Referee comment responses on the manuscript:

### ***First results of the polar regional climate model RACMO2.4***

by C.T. van Dalum et al.

#### **Review #1, from Oskar Landgren**

Figure 1: "Total amount of valid daily AWS data from the selected AWSs between 2006-2015, for different thresholds of allowed missing data per day. "

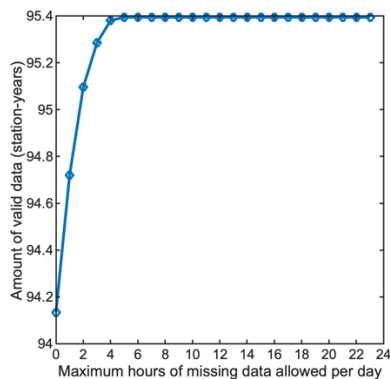
L265: Please motivate why the exclusion threshold is set as low as one missing hour per day. It sounds a bit aggressive to me, but perhaps there are very few days with only a few hours missing.

All days with at least one missing hourly measurement are not considered to remove the uncertainty when interpolating in between measurements, or when averaging partial data. This filter removes 460 days of data, or just 1.3% of the total 34 819 days of data when allowing for more than 5 hours of missing data per day or more (see attached Figure). We have included this information and hope that it becomes clearer in the revised manuscript.

L265: This filter removes 460 days (1.3%) of the total dataset.
